# HISTORIC LANDMARK COMMISSION STAFF REPORT

Drayton Condominiums  
Major Alterations  
PLNHLC2011-00112  
1121 E. First Avenue  
April 6, 2011

This is a request by Warren Lloyd of Lloyd Architects, representing property owner Alex Hertz, to replace existing windows on the front and sides of the property located at 1121 E. First Avenue which is a multi-family building.

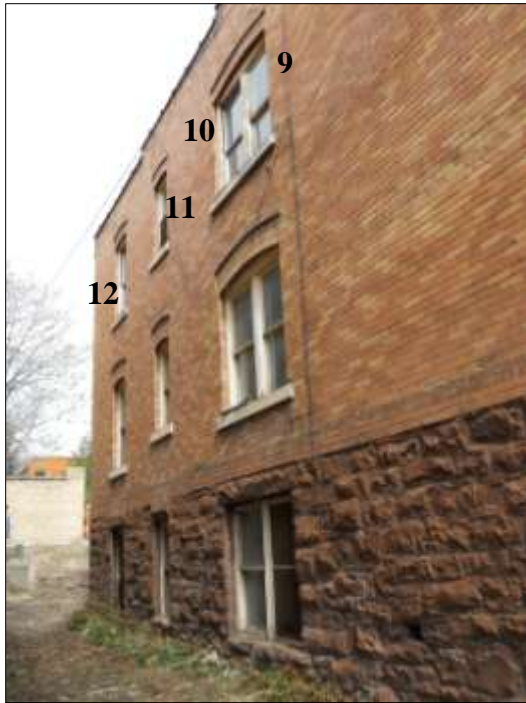
**East Façade**

<b>Number-Level</b>	<b>Condition</b>	<b>Proposed Treatment</b>	<b>Staff Recommendation</b>
01-Level 1	original/deteriorated	replace	replace
02-Level 1	original/sound	replace	repair
03-Level 1	original/sound	replace	repair
04-Level 1	original/sound	replace	repair
01-Level 2	original/sound	replace	repair
02-Level 2	original/sound	replace	repair
03-Level 2	original/sound	replace	repair
04-Level 2	original/sound	replace	repair
01-Level 3	Non-historic/sound	replace	replace
02-Level 3	original/sound	replace	repair
03-Level 3	original/sound	replace	repair
04-Level 3	original/sound	replace	repair

All wooden frames appear to be sound, with some repair needed in areas where deterioration results from a failure to provide adequate protection of materials. Sash joints have opened up in a number of cases, but few meeting rails appear twisted or warped. Several windows have broken glass. Earlier screen hardware is apparent on a few windows. The applicant indicates that most of the windows are painted or fixed shut, do not operate properly (weights, rope and pulley combination), and have some deteriorated sections of glazing putty and wood. For greater detail see Attachments A.

From the attached photographs and a site inspection, the original wood window 01-Level 1 on the east façade appears deteriorated. If the Commission were to consider a replacement window in this area, Planning Staff asserts that using a sash replacement would be the best approach. The metal windows are not original or consistent in design with the historic character of the building. In this instance, replacement would be an appropriate window treatment. Remaining original windows of this historic building could be rehabilitated, repaired, and upgraded with storm windows to make them energy-efficient while maintaining historic authenticity.

**Finding for Standard 6:** The proposal to replace sound original windows fails to meet Standard 6. The proposal to replace existing metal windows would be appropriate as these windows are not original and compromise the historical and architectural integrity of the building. The proposal to replace window 01-Level 1 should be allowed as more than 50 percent of the window components appear deteriorated beyond repair.
